# Access Compliance Report

## Public Rights-of-Way

### (Curb Ramps)

Intersection ID: 10032254	Main Street: MOSS_STREAM_LN	Cross Street: N/A	Location:	N
ADA ID: 0805A3429992	Ramp Type: Perp	Initial Pass/Fail: Fail	Overall Compliance: No	Severity Score: 8.75
Codes/Mitigation Info/Possible Solution		Field Measurements/Component Compliance

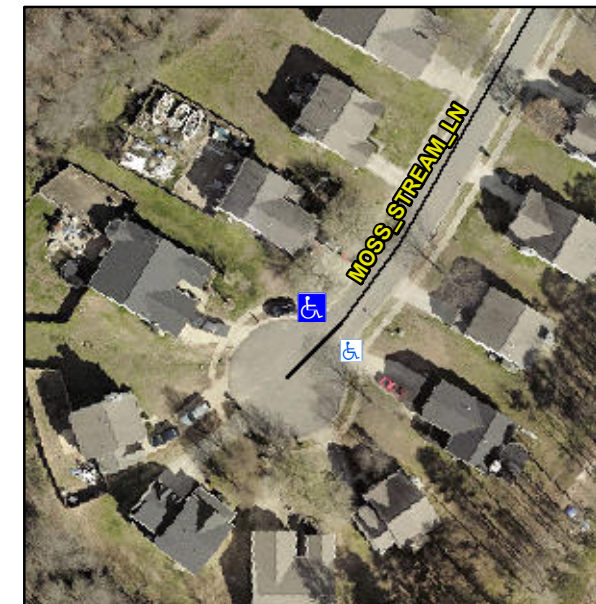
**Not Found, R304.5.1**

Compliance	Description	Data	Compliance	Description	Data
N/A	Ramp Length (in)	49.0	Yes	Ramp Slope (%)	5.5
No	Ramp Width (in)	44.5	Yes	Ramp XSlope (%)	1.7
N/A	Flare Type LT	N/A	N/A	Flare Type RT	N/A
N/A	Flare Slope LT (%)	N/A	N/A	Flare Slope RT (%)	N/A
N/A	Flare Traversable LT?	N/A	N/A	Flare Traversable RT?	N/A
N/A	Landing Length (in)	N/A	N/A	DWS Provided?	N/A
N/A	Landing Width (in)	N/A	N/A	DWS Contrast?	N/A
N/A	Landing Slope (%)	N/A	N/A	DWS Length (in)	N/A
N/A	Landing X Slope (%)	N/A	N/A	DWS Full Width?	N/A
N/A	Landing Curb? (Y/N)	N/A	N/A	DWS Offset (in)	N/A
N/A	Shared Landing?	N/A			
N/A	Gutter Ponding?	N/A	N/A	Gutter Slope (%)	N/A
N/A	Gutter Lip Ht (in)	0.8	N/A	Gutter X Slope (%)	N/A
N/A	Painted X Walk1?	No	N/A	Painted X Walk2?	N/A
	X Walk 1 Direction	To S		X Walk 2 Direction	N/A
N/A	X Walk 1 Width (in)	N/A	N/A	X Walk 2 Width (in)	N/A
	X Walk 1 Slope (%)	4.0		X Walk 2 Slope (%)	N/A
	X Walk 1 X Slope (%)	0.6		X Walk 2 X Slope (%)	N/A

N/A	Ramp inside XWalk1?	N/A	N/A	Ramp inside XWalk2?	N/A
	Road Slope (%)	N/A	N/A	Clear Space?	N/A
	Road X Slope (%)	N/A	N/A	Clear Space to XWalk (in)	N/A
N/A	Any Obstructions?	N/A	N/A	Storm Grate/Utility Hazard?	N/A
	Obstruction Type			Storm Grate/Utility Type	
		N/A			N/A
			Yes	Surface Condition? (G/P)	Good

**Remove & Replace Entire Ramp.**
